ADDITIONAL CHANGES PREVIOUSLY
PROPOSED BY LETTER
Serial No. 2210 Date 03/30/94

DAVIS-BESSE, UNIT 1

REACTOR COOLANT SYSTEM

New TS 3.4.5 Limiting Condition for Operation

Figure 3.4-5
Maximum Allowable Steam Generator Level
in MODES 1 and 2

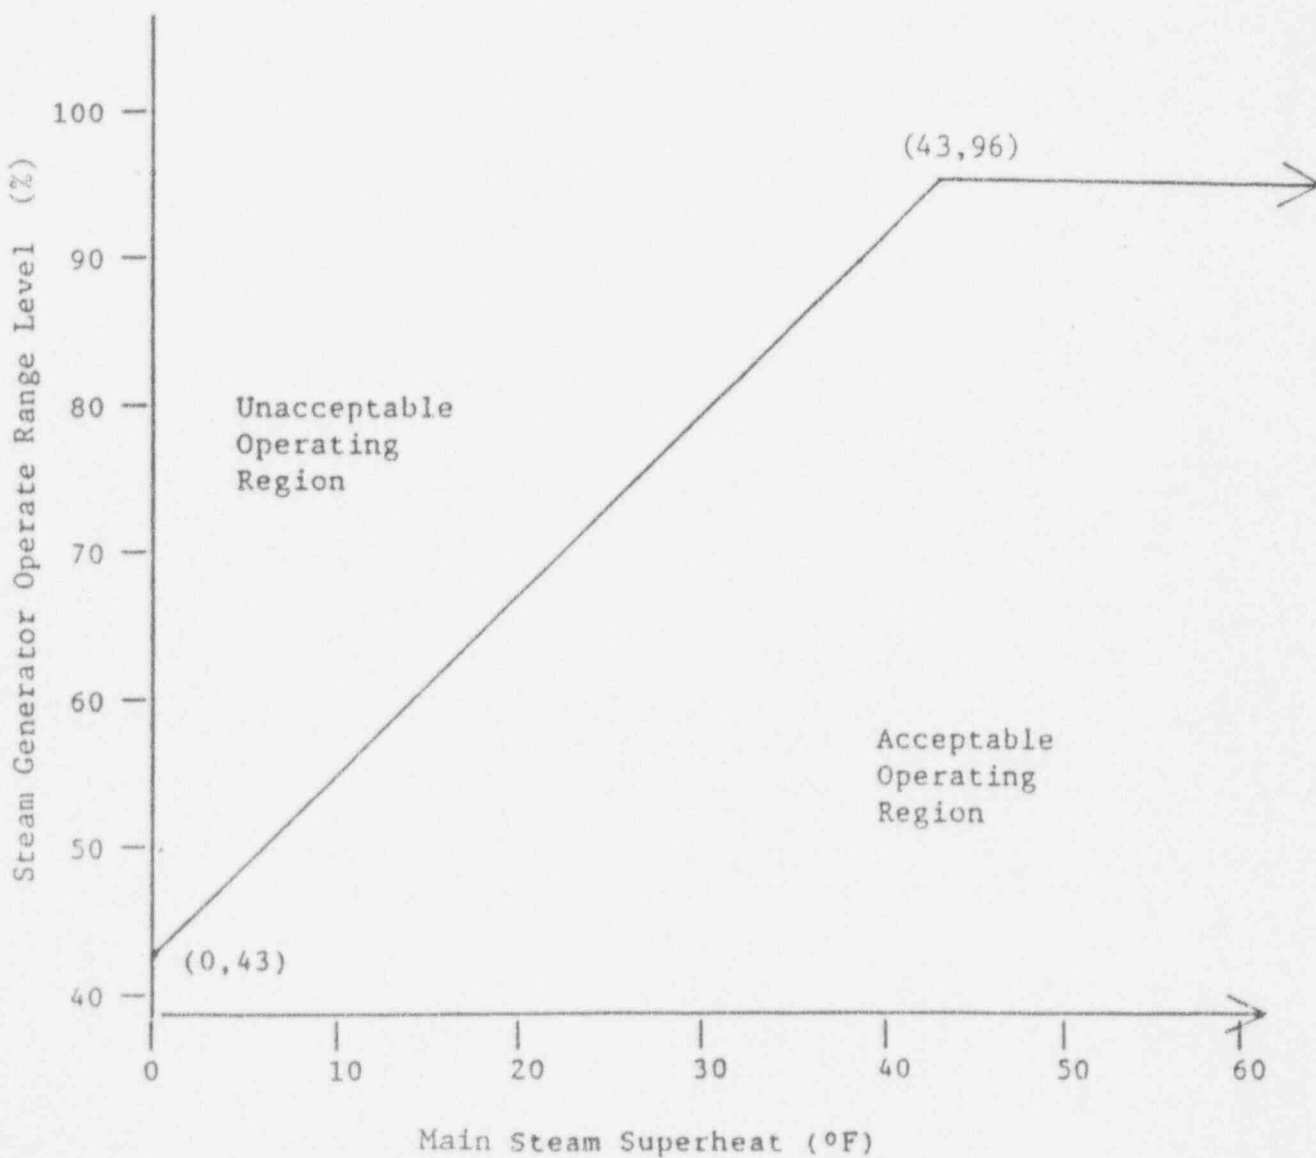
- a. The acceptable operating region of Figure 3.4-5.

NEW Figure 3.4-5 TO BE INSERTED
AS NEW PAGE 3/4 4-6 a

3.4.5 Each Steam Generator shall be OPERABLE with a minimum water level of 18 inches and the maximum specified below as applicable:
